CITY OF ALBUQUERQUE

RE: 1321 & 1325 Van Cleave Rd. NW
Grading and Drainage Plan
Engineer's Stamp Date: 02/22/23
Hydrology File: G13D043

Based upon the information provided in your submittal received 02/28/2023, the Grading & Drainage Plan is approved for Grading Permit (earthwork can get started for the earth pad on the house).

HELLER, ADAM - GRADING & DRAINAGE PLAN

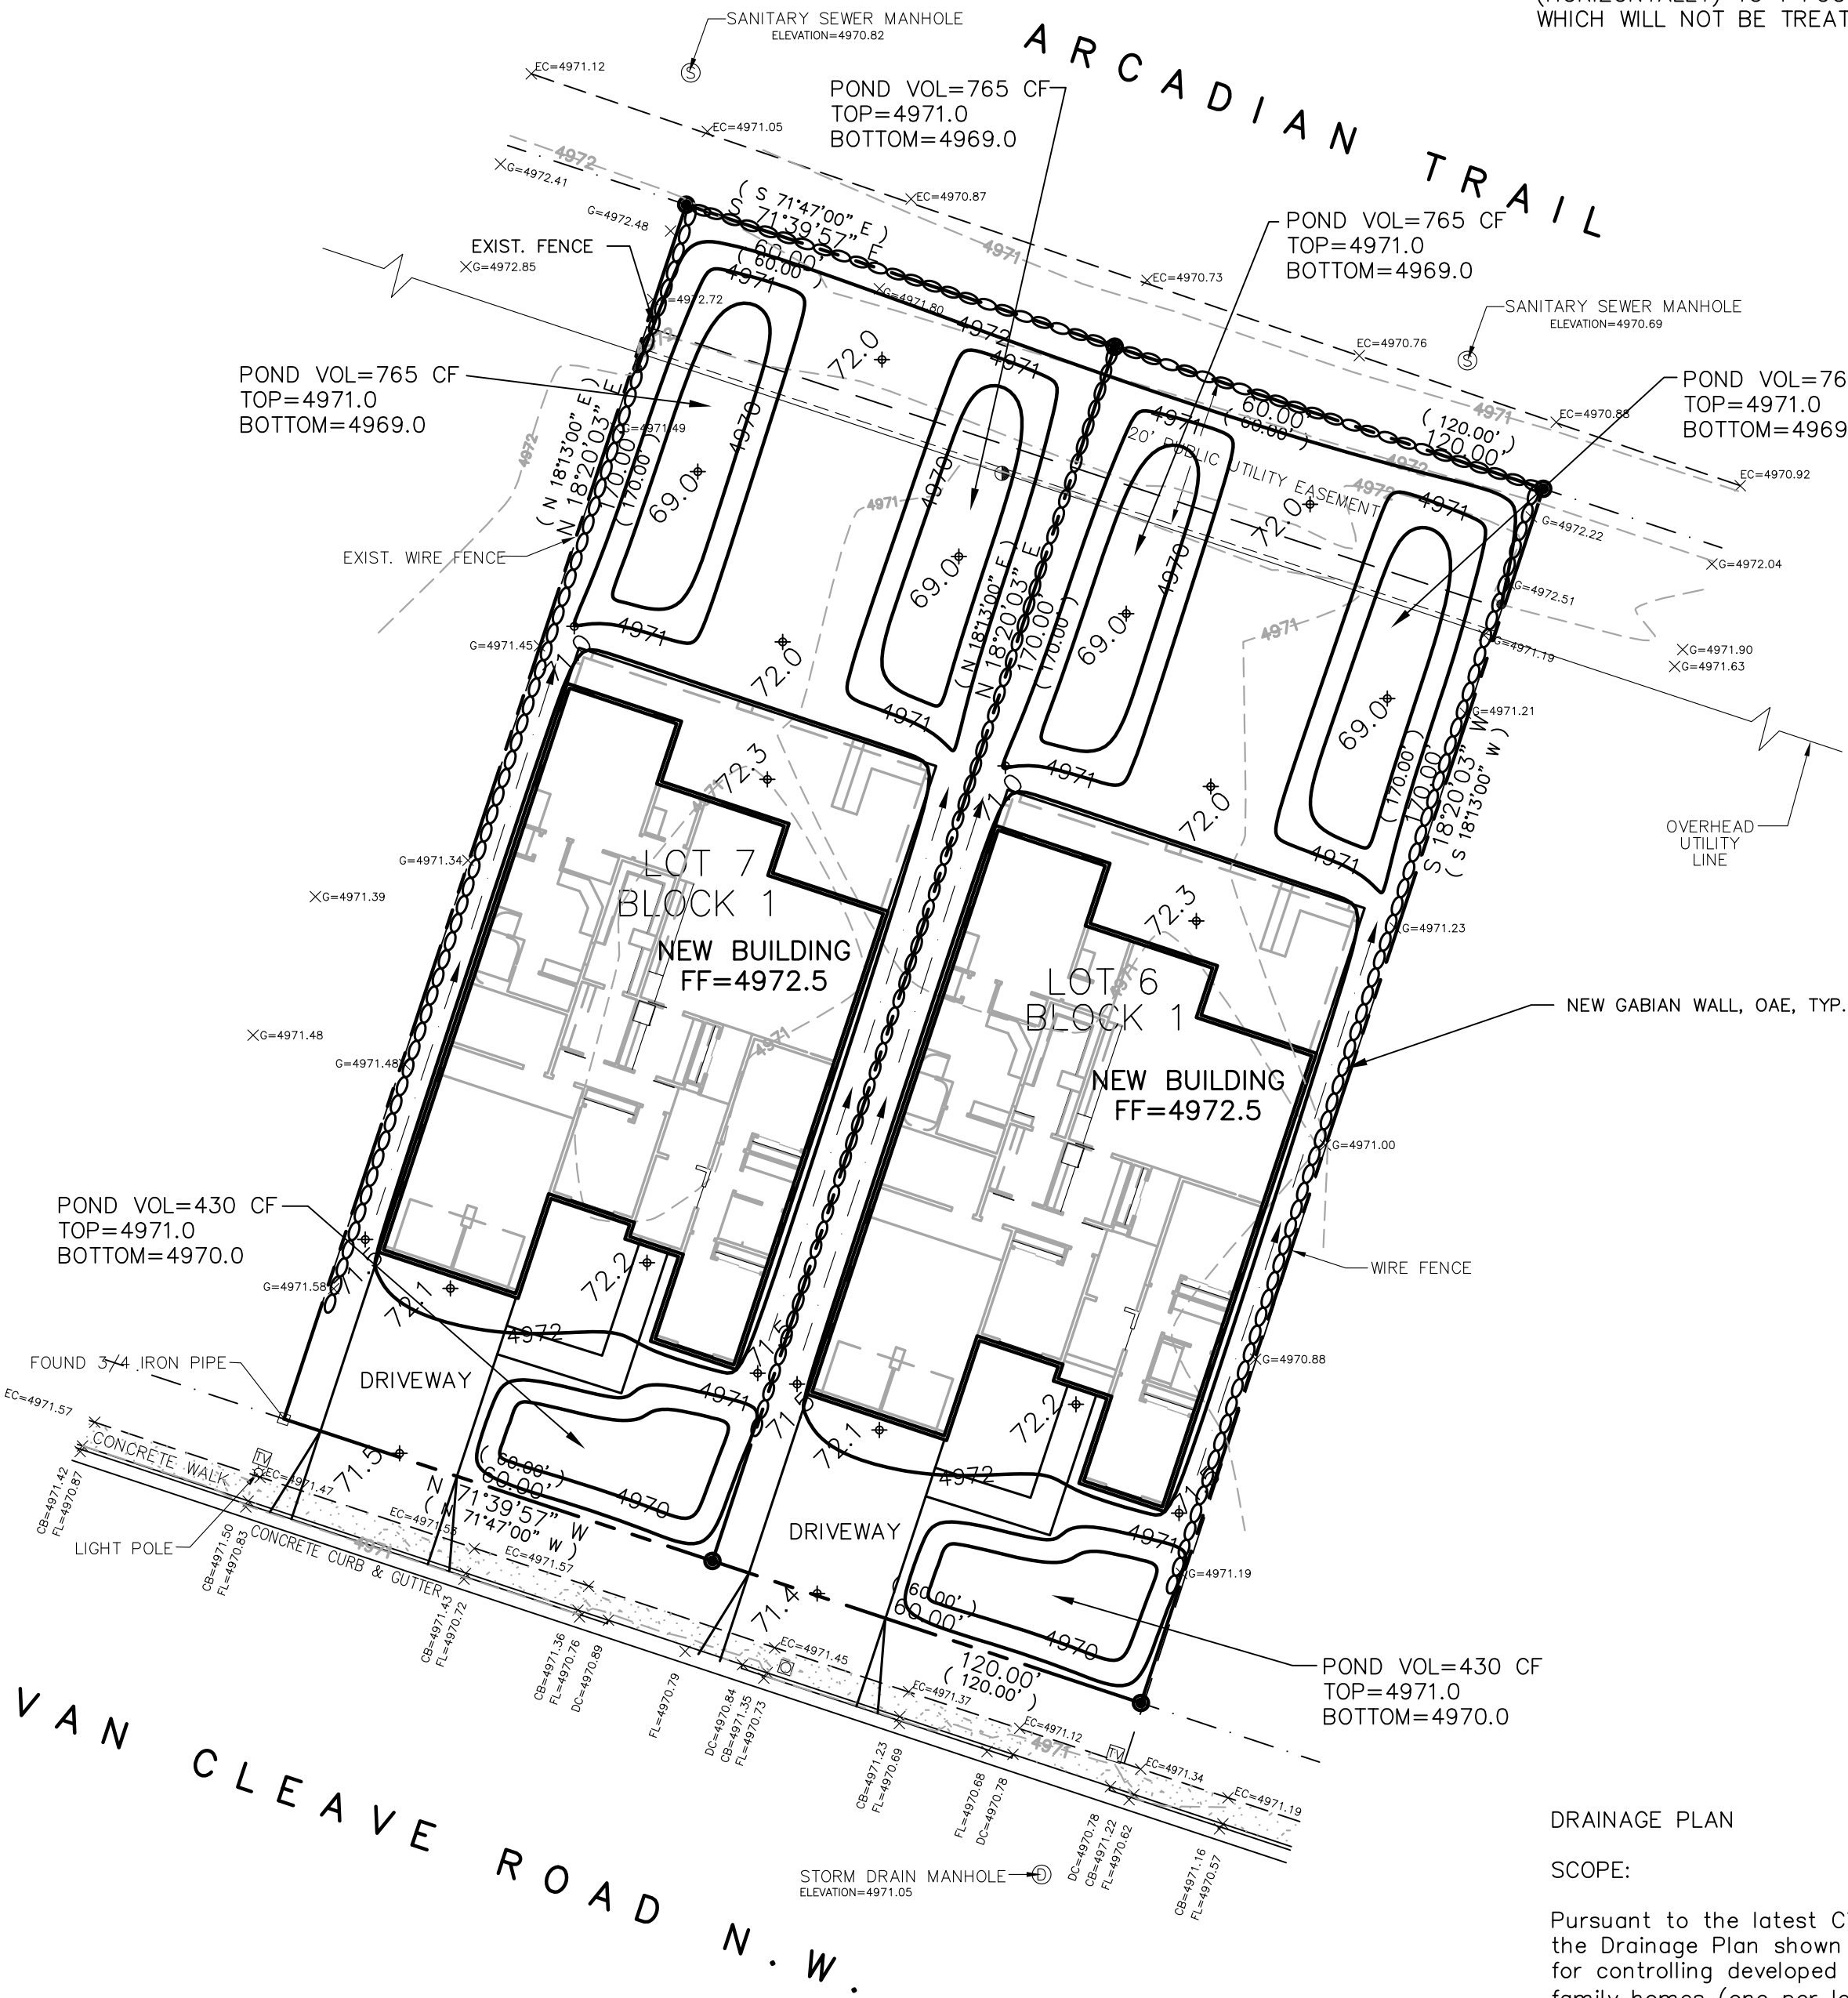
1. Once the grading is complete, a pad certification (meaning that the earthwork is complete) will be required. **Please include a site photo with the submittal.** Also, at the time of pad certification approval, Hydrology will concurrently approve the Grading & Drainage Plan for Building Permit.
2. Please show that the two existing drive pads are being replaced with new curb & gutter and sidewalk.

3. Also, please separate the two since there will be two separate Building Permits pulled. Please just place a big "X" over the lot that does not go with each address.
